SPRING HILL PD

A PORTION OF SECTION 6, TOWNSHIP 1 NORTH, RANGE 68 WEST OF THE 6TH P.M.,
TOWN OF ERIE, COUNTY OF WELD, STATE OF COLORADO
299.514 ACRES - 632 LOTS / 46 TRACTS
PD-001263-2021

From: [Audem Gonzales](#)
To: [John Prestwich](#); [Matt Janke](#); [Chris Elliott](#)
Cc: [Luke Bolinger](#); [Darren Champion](#)
Subject: Spring Hill PD Town Review
Date: Thursday, June 17, 2021 4:23:06 PM
Attachments: [image001.jpg](#)
[Development Referral Spring Hill - Planned Development - PD-001263-2021 Parks and Rec Comments.msg](#)
[RE EXTERNAL MAIL Referral Review - Spring Hill PD.msg](#)
[Planning Redline.pdf](#)
[2021 5-12 MVFPD.pdf](#)

The Town of Erie completed the review for the Spring Hill PD zoning document. Please find Planning comments below and attached to this email in the form of a redlined PD document. I have also attached other review comments that have been received at this time.

SHEET NAME
PD PLANNING AREAS

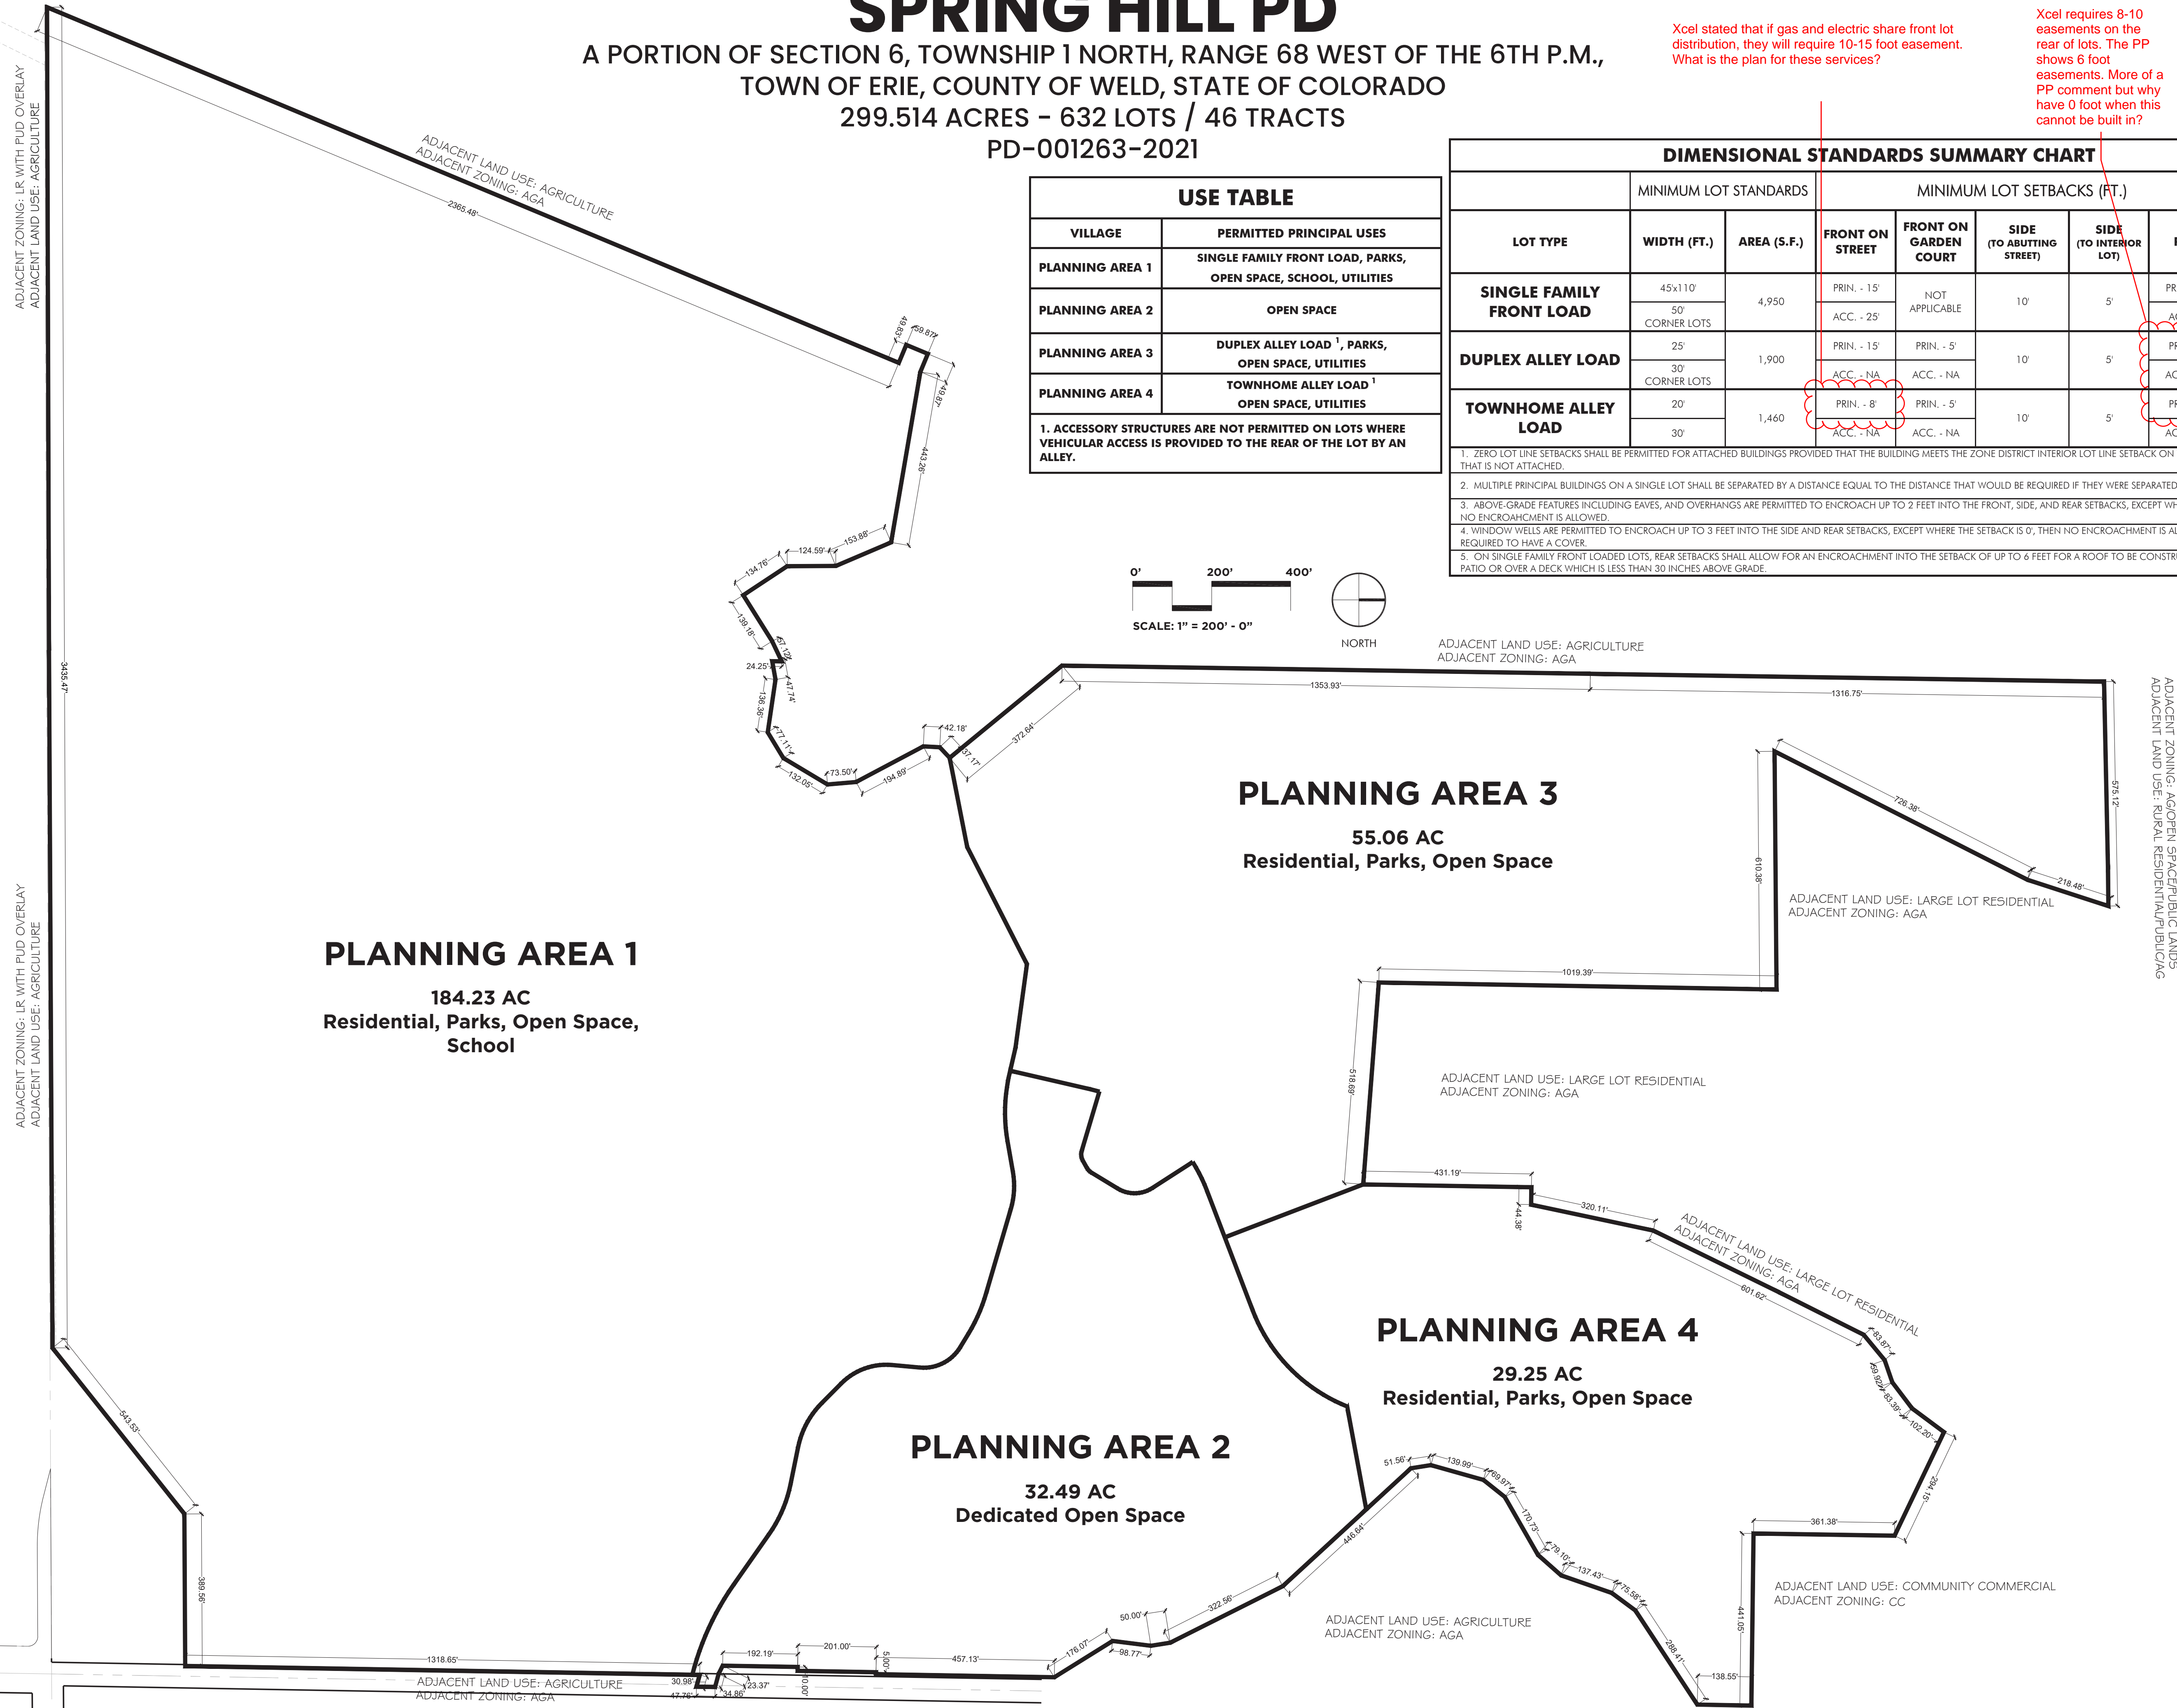
Xcel stated that if gas and electric share front lot distribution, they will require 10-15 foot easement. What is the plan for these services?

Xcel requires 8-10 easements on the rear of lots. The PP shows 6 foot easements. More of a PP comment but why have 0 foot when this cannot be built in?

COVER SHEET

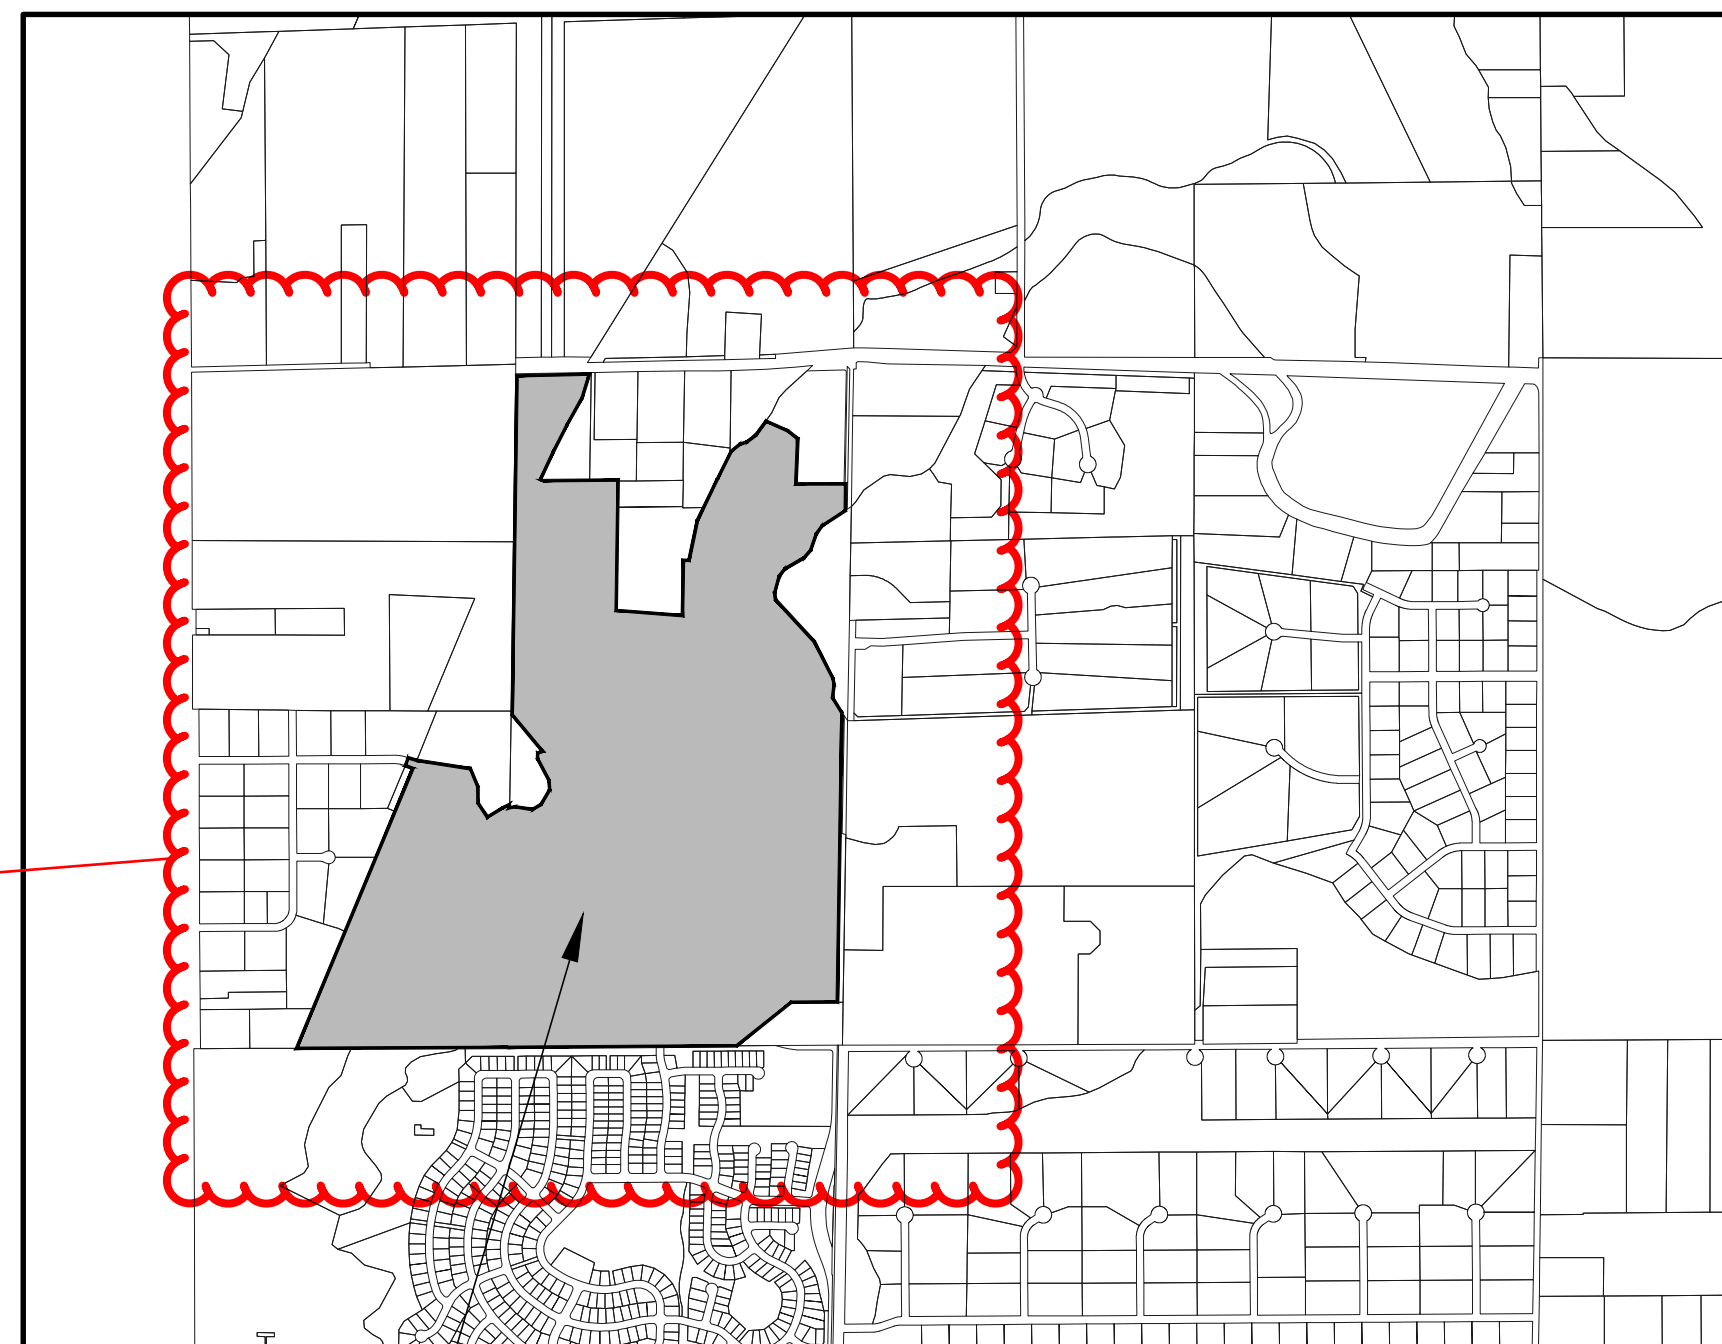
Move notes to this area of the sheet. Include applicability section here. What zone district does it default to? Is it subjective enough that staff would assign the zone district in Code?

Sheet Name
PD PLANNING AREAS

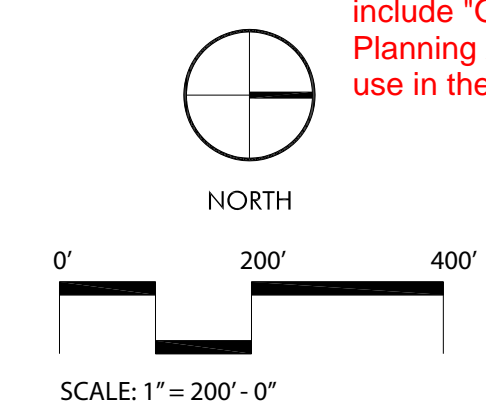
Is this property a separate planning area?

Remove oil and gas setbacks but keep well head locations. Label well heads.

- UTILITY EASEMENTS MAY BE MORE RESTRICTIVE THAN MINIMUM SETBACKS, THE GREATER OF THE MINIMUM SETBACK OR THE UTILITY EASEMENT SHALL GOVERN.
3. Rewrite as "Above grade features XX XX are permitted to encroach up to 2 feet into the front, side and rear setbacks. 4. same language as 3 - "Window wells XXXX are permitted to encroach up to 3 feet into the side and rear setbacks, except for XX. 6. Remove this provision all together or simply state that no buildings or encroachments are permitted into easements.

Remove all of these easements, etc. Do not need to be shown on PD.

Remove Spine Trail

Areas for townhomes and duplexes should be separated into their own Planning Areas. 1. Single-family homes, 2. Townhomes, 3. duplex. etc. It's cleaner and shows the boards how the density is split.

There are no measured distances for the property boundaries. Show on next submittal for all exterior PD boundary. Individual villages do not need measurements.
